**PR/0480/22**

## Record of Executive Business and Chief Executive's Order

**Reg. Reference:** SD21B/0621      **Application Date:** 14-Dec-2021  
**Submission Type:** Additional      **Registration Date:** 15-Mar-2022  
Information

**Proposed Development:** Construction of a porch, garage conversion, change of facade finishes, additional vehicular entrance and parking space, bicycle and bin shelters, all to front and ground floor single storey extension to the rear and attic conversion with dormers to front and rear and 'Velux' type roof window to the front.

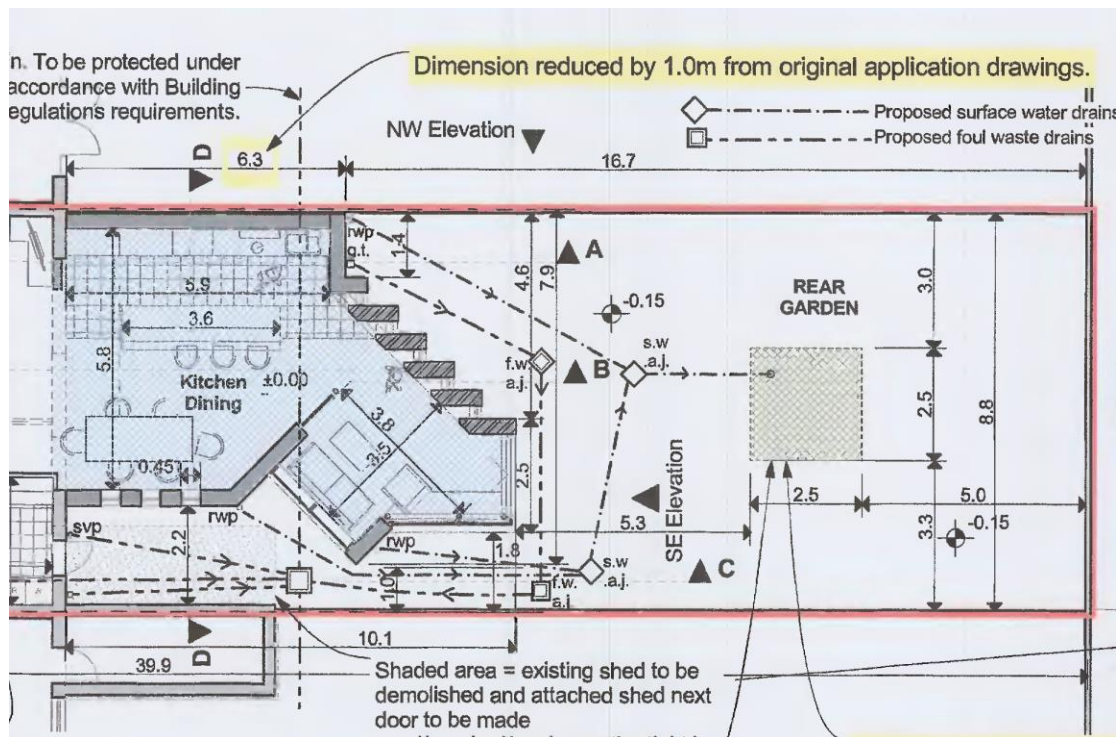
*1.1 The soakaway test pit excavated is too shallow at 1m as the proposed soakaway has a depth of 1.5m. Soakaway tests need to be excavated to sufficient depths to determine that the presence of ground water will not adversely affect the soakaway performance. The applicant is required to carry out and submit revised soakaway tests and calculations in accordance with BRE Digest 365 standards to demonstrate that groundwater will not adversely effect the performance of the proposed soakaway.*

*1.2 Submit a revised drainage drawing showing the inclusion of water butts and permeable paving in driveways as part of additional SuDS (Sustainable Drainage Systems) measures for the proposed development.*

Notwithstanding the report from Surface Water Drainage it is considered that the above may be dealt with by way of **condition** whereby prior to commencement of development the applicant shall submit to the Planning Authority for written approval a revised soakaway test to demonstrate that groundwater will not adversely affect the performance of the proposed soakaway.

The Planning Authority considers the applicant has satisfactorily responded to the request for additional information for this item.

### AI Response

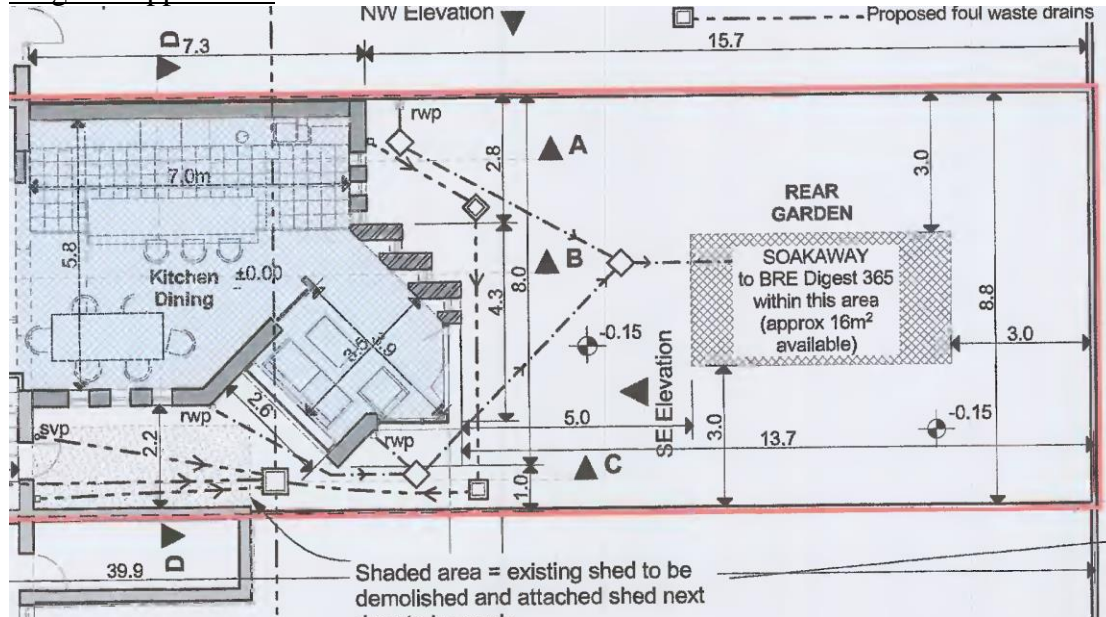
Having regard to the rear extensions to the adjacent dwellings north and south and to the 7.3m depth of the proposed extension along the northern boundary, it is considered that the depth along the northern boundary is excessive and should be reduced to approximately 6m to mitigate impact on adjacent dwellings. The applicant is requested to submit revised plans accordingly.

- b) Your item 2, seeking further information relative to reducing the length of the rear extension along the Northern boundary; the revised drawings submitted proposes a reduction in this rear depth of 1.0m giving a total dimension of 6.3m along the Northern boundary.

It is clear from the revised drawing submitted has reduced the depth of projection of the proposed extension along the northern boundary from 7.3m to 6.3m. This reduction in projection is considered to mitigate against adverse impact on adjacent dwellings.

The Planning Authority considers the applicant has satisfactorily responded to the request for additional information for this item.
